ADDENDUM 04

Date: March 17, 2022

Project Name: Gregg County Parking Garage and Office

SHA Project No.: 20011

A2.8

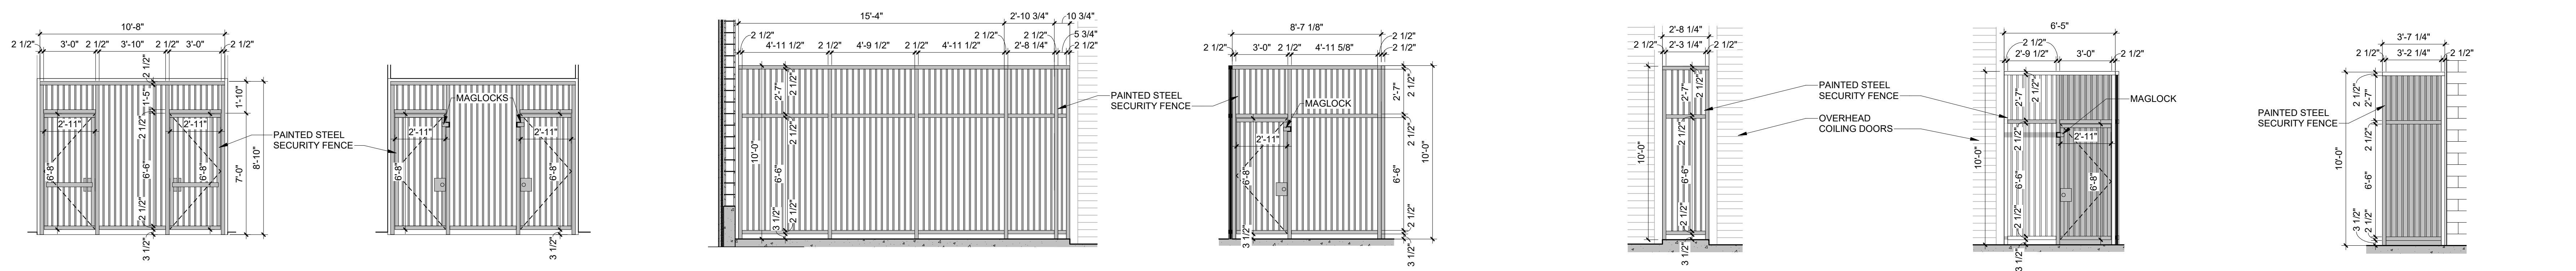
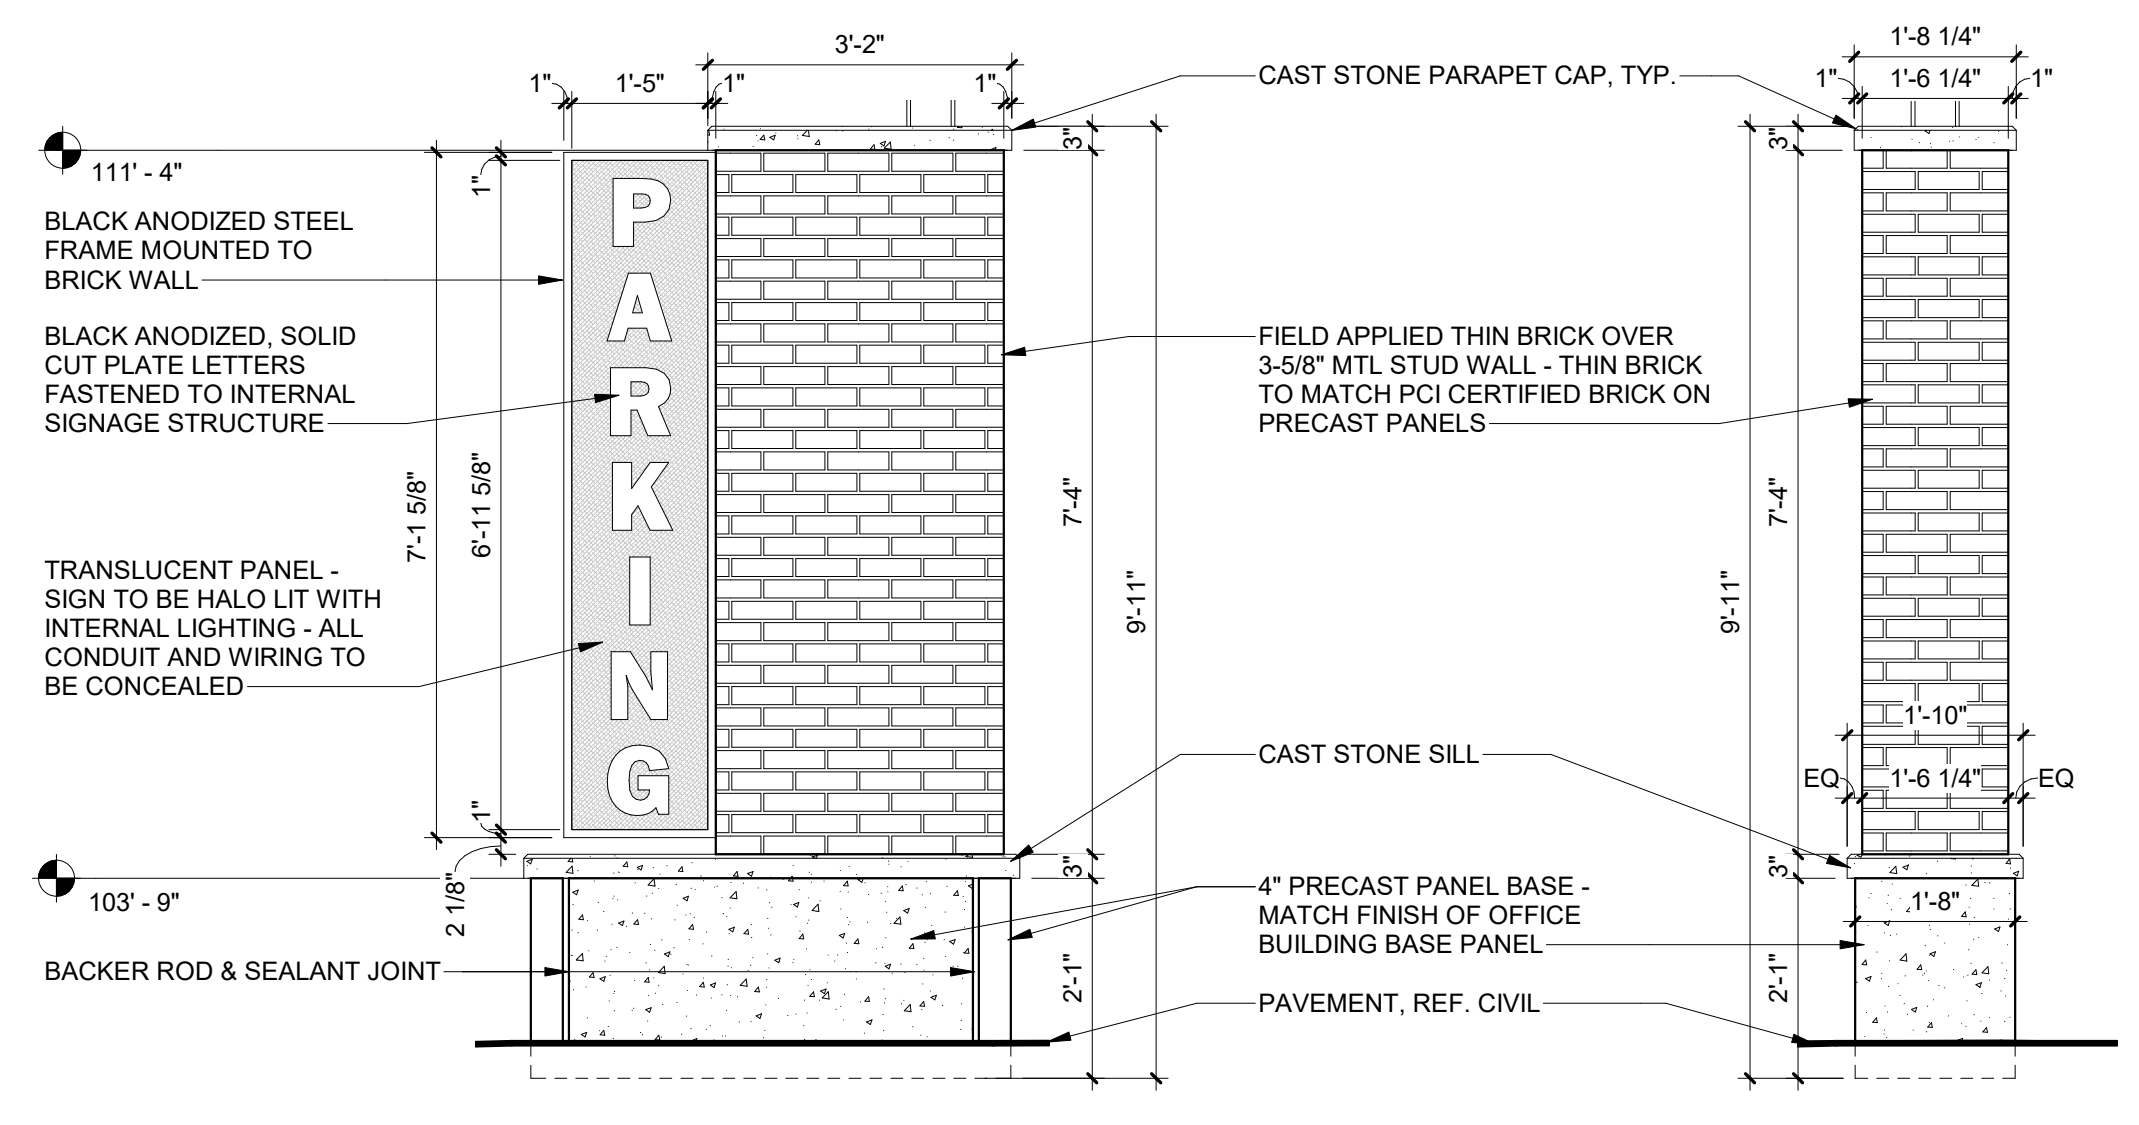
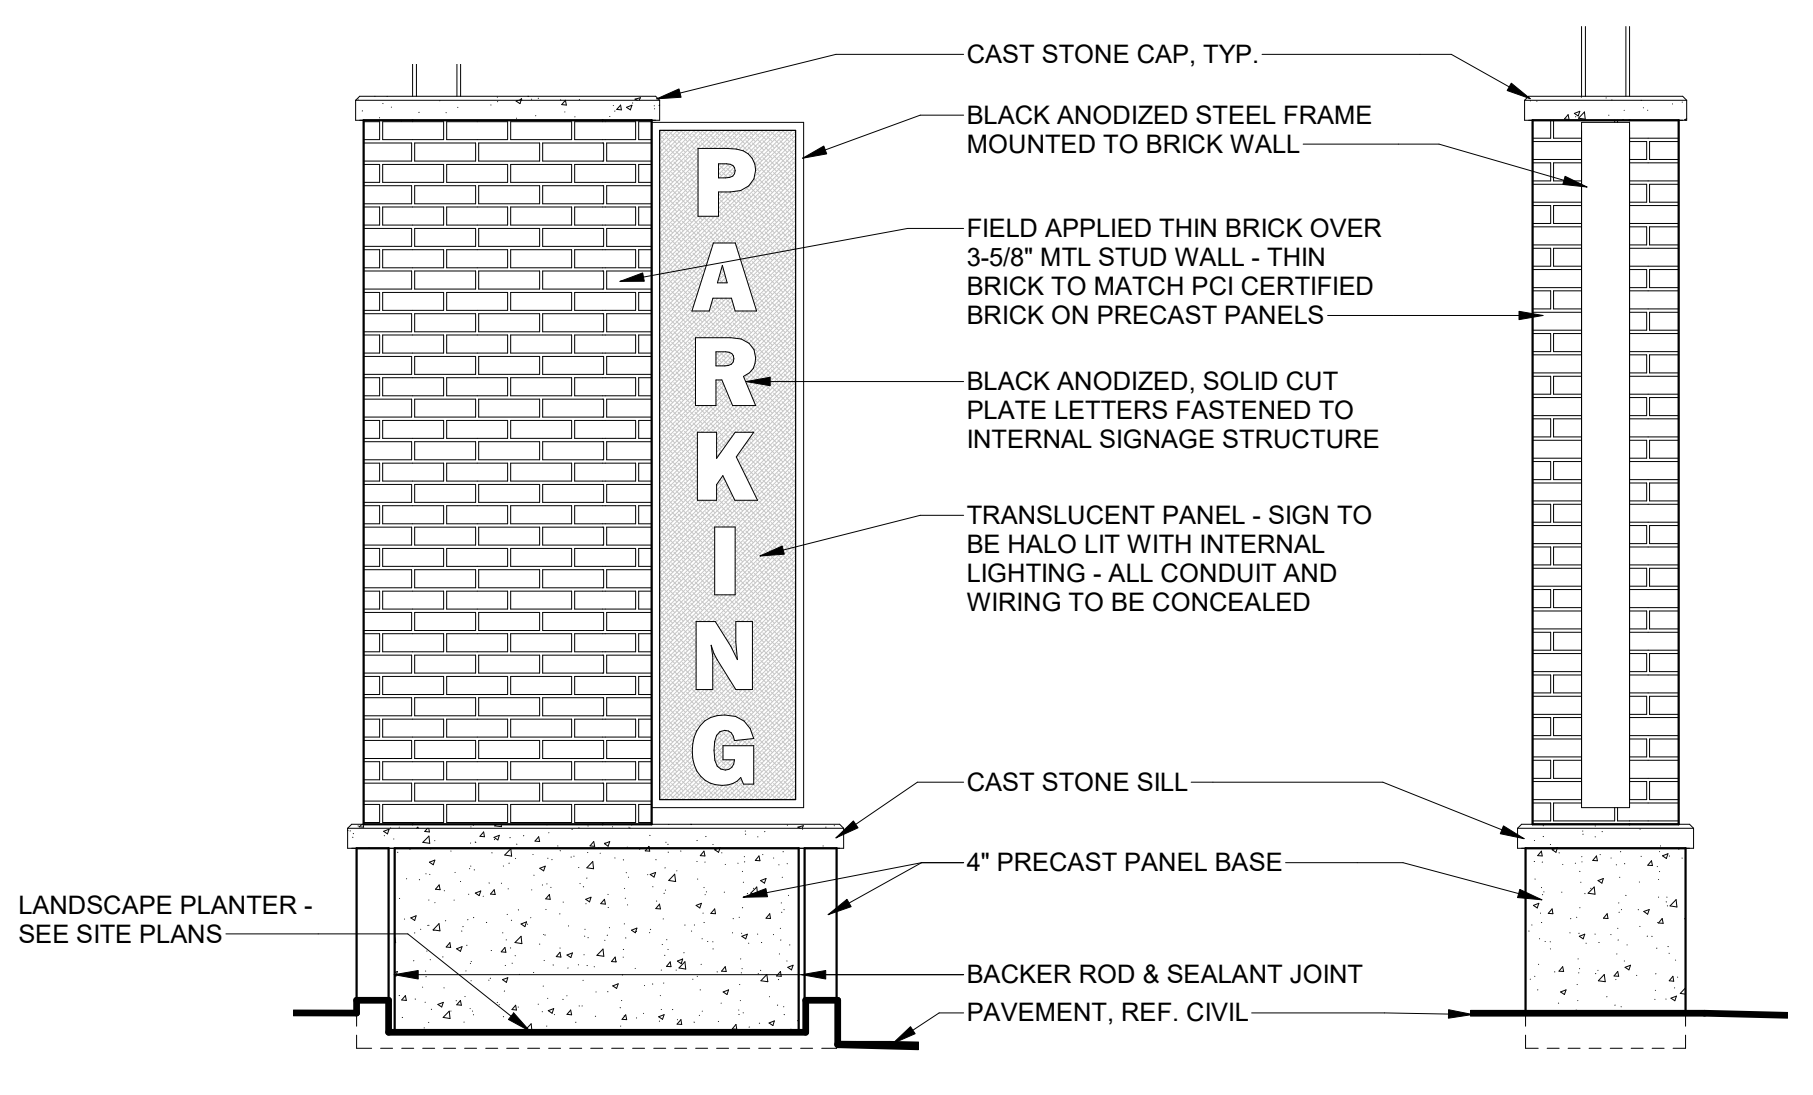
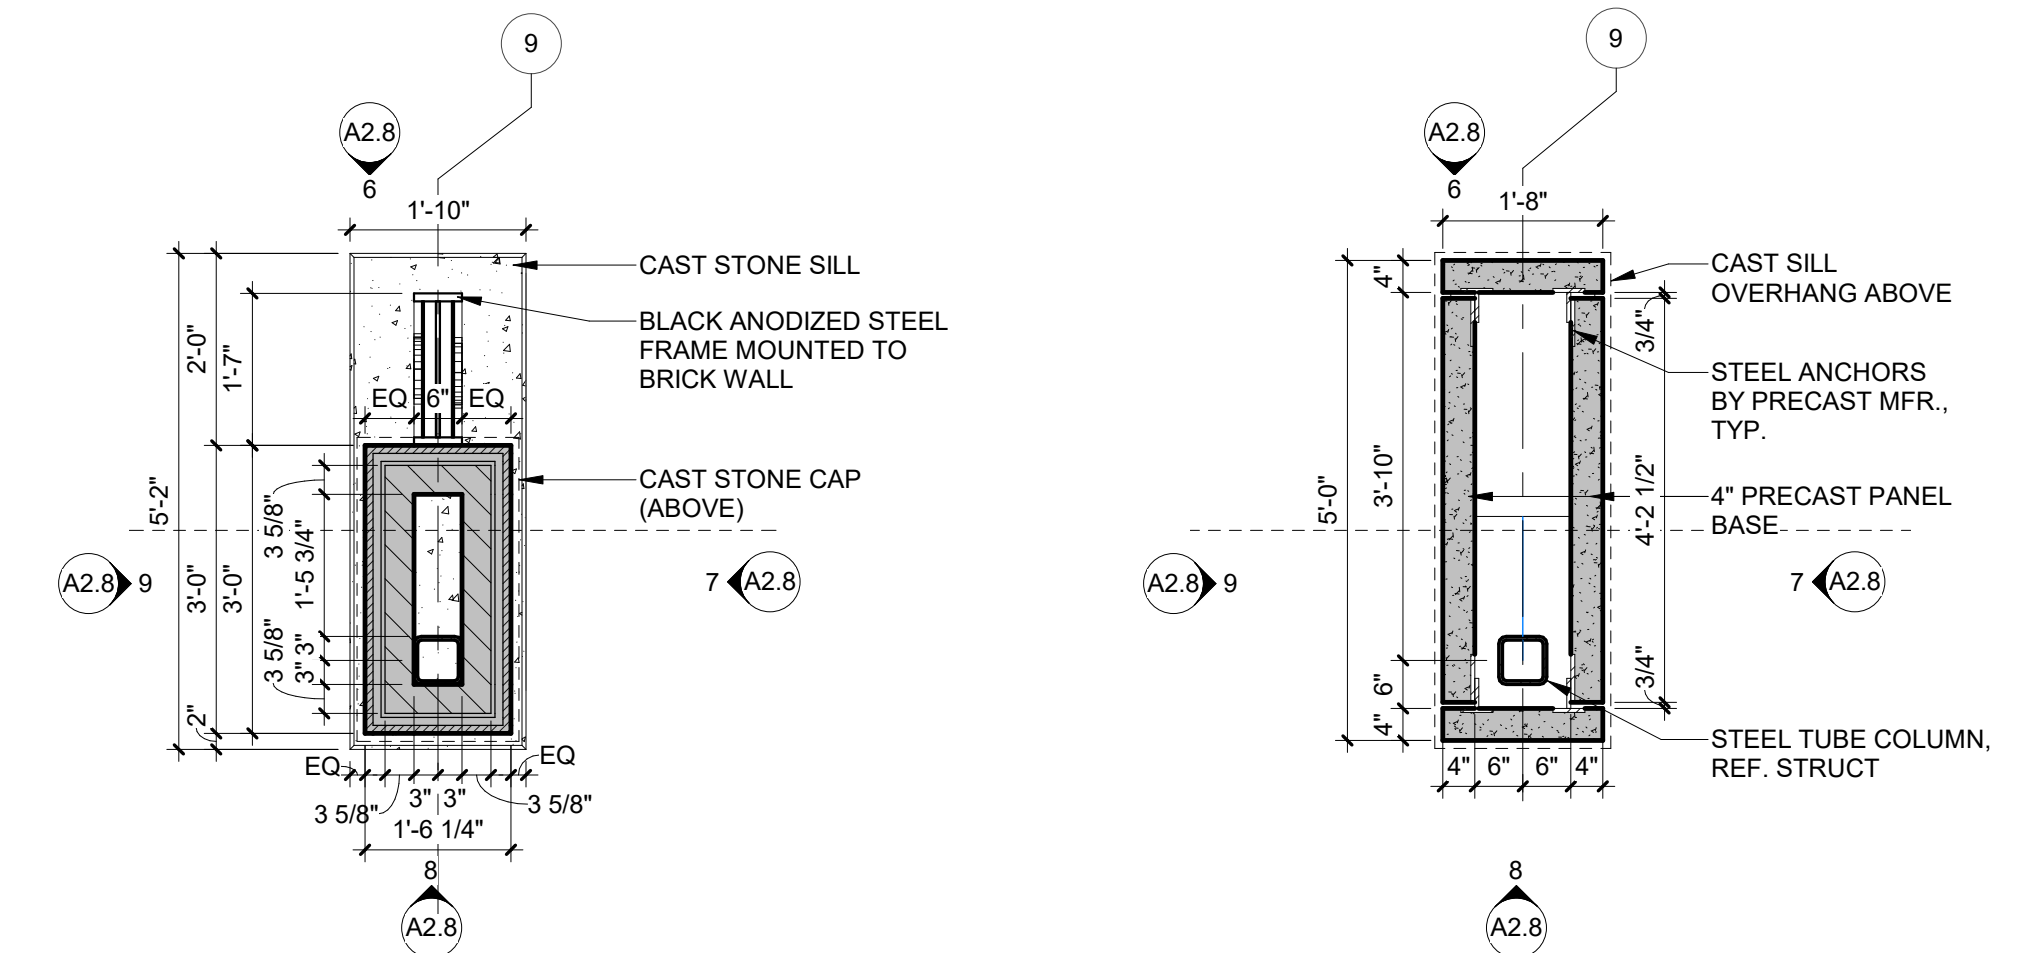
Question #A15: Please have the Architect provide more information for the clouded items on the attached garage entry plan.

Response #A15: Sheet A2.8 was revised to show more annotations regarding the clouded bollards and vehicle entry equipment. Also, refer to sheet(s) AG101, S101, & E401 for further clarification.
